### RE: Structural Documentation Review of Lake Park Arch Bridge – Phase 1

**Re: Lake Park Arch Bridge over Ravine Road – Phase 2: Concrete Testing Results**

Subject: Presentation of test data for existing concrete for  
Lake Park Footbridge over Ravine Road  
Milwaukee, Wisconsin  
Giles Project No. 1M-1803020-REV

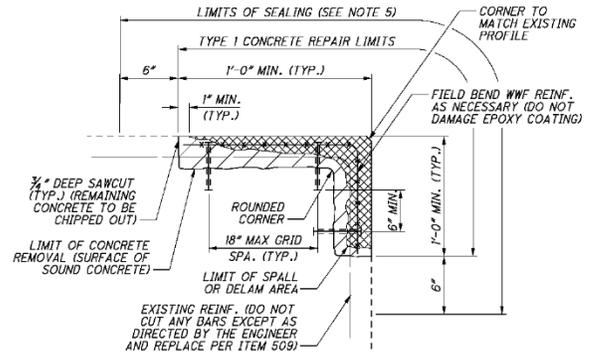
Based on our cursory site visit, there has not been any significant change in the condition of the bridge since the 2015 inspection. Many of the conditions noted in the field are a combination of failures of previous patch work and poor construction practices. The deck delaminations appear to be due to a lack of concrete cover over the reinforcing steel. This is evident in that the reinforcing bars are still bonded with the concrete for the majority of the circumference of the bars. While section loss of the steel may be present, the amount of loss is most likely not significant. Therefore, cleaning and rehabilitating several of these areas with the exposed reinforcing is a viable option as long as the material testing of the concrete concludes these types of repairs are compatible.

Figure 1 – Freeze-thaw analysis test results (from Giles Engineering Associates, Inc. report dated June 14, 2018).

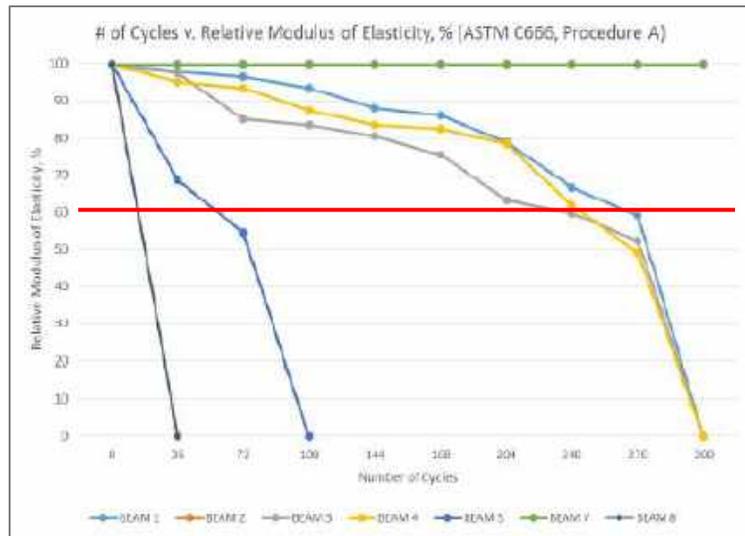
The results of the freeze-thaw analysis confirmed that without an effective air-entrained void system, the relative dynamic modulus of elasticity reduced quickly when subjected to numerous freeze-thaw cycles. According to ASTM C666, the specimens being tested are subjected to cycles of freezing and thawing, and their frequencies are then measured to determine the change in relative modulus as a function of these cycles. The tests are to be continued until the specimen reaches the desired 300 cycles or until its relative dynamic modulus of elasticity is drops below 60% of the initial modulus, whichever comes first, unless other limits are specified.

Based on the test results, the relative dynamic modulus of Beams 2 and 8 (center floorbeam and west arch rib, respectively) reduced to zero after the initial 36 cycles. The relative modulus of Beam 5 (west spandrel wall) dropped below the 60% threshold between 72 and 108 cycles. Beam 1 (top of east parapet), Beam 3 (first floorbeam north of midspan), and Beam 4 (east arch rib near south thrust block) dropped below the 60% threshold between 240 and 276 cycles. Beam 7 (south thrust block) did not experience any notable reduction in its dynamic modulus of elasticity and remained in good condition over the full 300 freeze-thaw cycle; this is because Beam 7 consisted of modern concrete with an effective air-entrained void system which allows for water trapped within the concrete to freeze and thaw freely without causing damage.

Although WisDOT does not have a specification for relative dynamic modulus of elasticity or durability factor, the United States Army Corps of Engineers and Federal Aviation Administration typically require projects to have a relative dynamic modulus of elasticity greater than 75% for new concrete. All beam samples except Beam 7 fell below this targeted threshold for modern job mix formulas for concrete. This would be expected with concrete from this era which lacks an effective air void system to accommodate freeze-thaw cycles within the specimens. However, while these test results suggest that the original concrete has a less than desirable resistance to freeze-thaw cycles, the testing procedure clearly states that “neither procedure [from ASTM C666] is intended to provide a quantitative measure of the length of service that may be expected from a specific type of concrete.” As a result, the remaining service life of the concrete cannot be concluded from this freeze-thaw analysis.

While the freeze-thaw analysis shows that the bridge has less than desirable durability against cycles of freezing and thawing, this is not an indicator of the structural integrity of the bridge. The compressive strength of the structure dictates the load-carrying capacity of the bridge. Chloride content and the petrographic analysis provide information regarding the condition of the structure and possible deterioration that has occurred over time. The lack of freeze-thaw resistance in this structure can be partially mitigated by reducing the infiltration of water inside structural members, which can be done by sealing the concrete surfaces or improving the drainage system on the structure.
